# SOUTHERN ENVIRONMENTAL LAW CENTER

October 1, 2019

**RE: New information regarding the proposed landfill site for Oak Ridge Reservation Comprehensive Environmental Response, Compensation, and Liability Act Waste.**

**Figure 1. Site Characterization: Groundwater Levels.**<sup>17</sup>

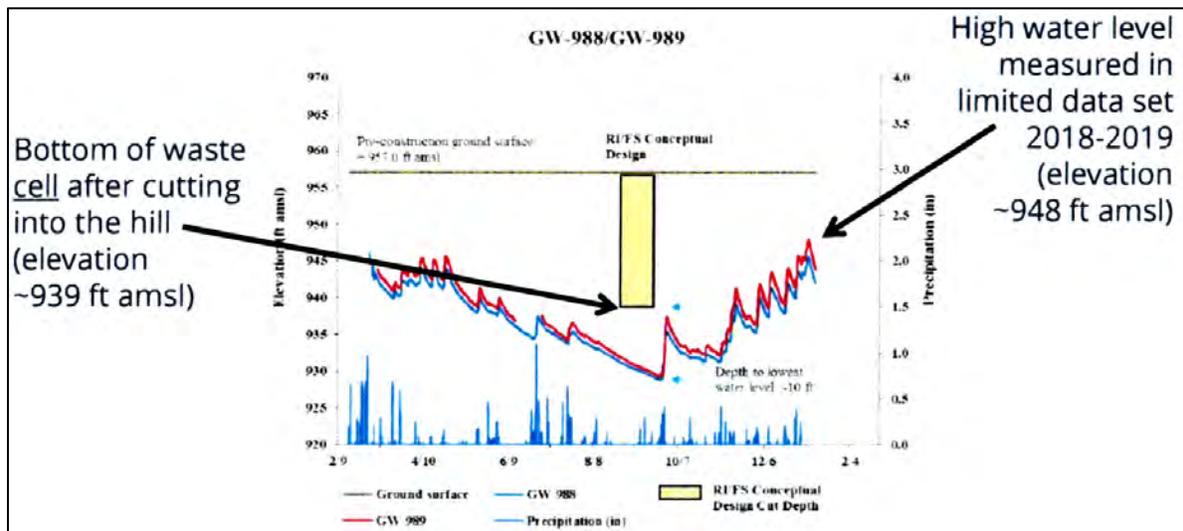
New groundwater information significantly changes the features of the remedy the Department has proposed: to construct a landfill that would taint a greenfield on the Oak Ridge Reservation (the Proposed Plan).<sup>11</sup> In the Proposed Plan, the Department claimed the location was the “most appropriate area on the [Oak Ridge Reservation] for locating an onsite disposal facility” in part due to its “groundwater flow conditions,” citing the “considerable amount of information” available about the subsurface and groundwater conditions in Bear Creek Valley.<sup>12</sup> At the time of the public comment period, the Department told the public that the landfill would maintain a “10 ft geologic buffer above seasonal high groundwater.”<sup>13</sup> The Department said that “[r]esults of the Phase 1 site characterization confirm the acceptability of the [landfill] site for a new, low-level waste landfill and support final site selection.”<sup>14</sup> However, recently released Technical Memorandum 2 reveals that groundwater levels at the site are significantly higher than originally anticipated and understood.<sup>15</sup> According to the new groundwater information, a substantial portion of the landfill would sit below the water table.<sup>16</sup> (Figure 1).

The newly revealed groundwater levels at Bear Creek Valley raise critical questions about the design and performance of the landfill as proposed. The U.S. Environmental Protection Agency’s (EPA) comments on Technical Memorandum 2 underline that the proposed landfill must have “a completely unsaturated clay geobuffer layer to demonstrate the protectiveness requirements necessary to obtain waivers.”<sup>18</sup> However, the landfill as proposed would sit below the water table, and there is a substantial risk that waste would not be adequately contained.<sup>19</sup> The Tennessee Department of Environment (TDEC) stated that Technical Memorandum 2 “raises significant questions about how [the Department] will support the contention that the [proposed landfill] site is acceptable.”<sup>20</sup> More explicitly, TDEC stated that Technical Memorandum 2 “makes it difficult to determine if the landfill can be constructed and operated in a manner that will meet the two CERCLA threshold criteria.”<sup>21</sup> In the wake of this new information, the Department has not altered the Proposed Plan or given the public an opportunity to comment on the issues raised by this new information.
